**ADDENDUM NO. 1
TO
PLANS AND SPECIFICATIONS
FOR THE
WASTEWATER TREATMENT IMPROVEMENTS

SWEET SPRINGS, MISSOURI**

Addendum No. 1

**CUSTOMER SELF CONTAINED
120/240V METER STAND**

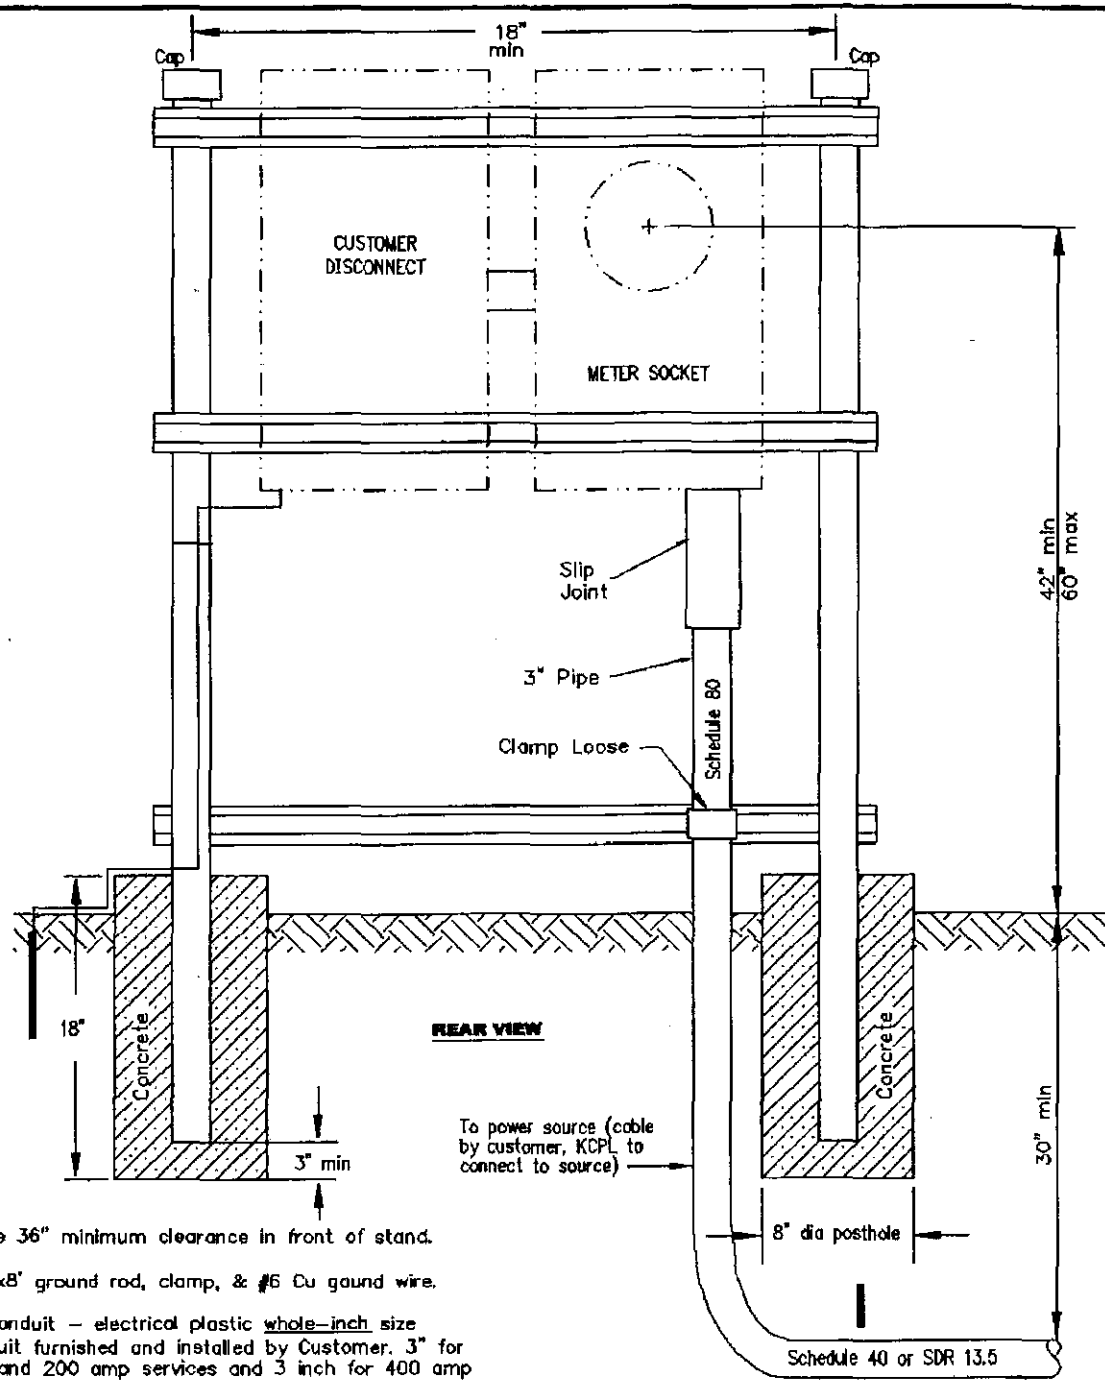
- a. KCP&L has been contacted for the service upgrade. The contractor shall install a new meter stand adjacent to the existing transformer pole in accordance with the attached KCP&L Standard. 3" conduit shall be extended to the existing pole and installed per KCP&L Standards. NOTE: Service is 120/208V Three phase even though the detail from KCP&L notes 120/240V.
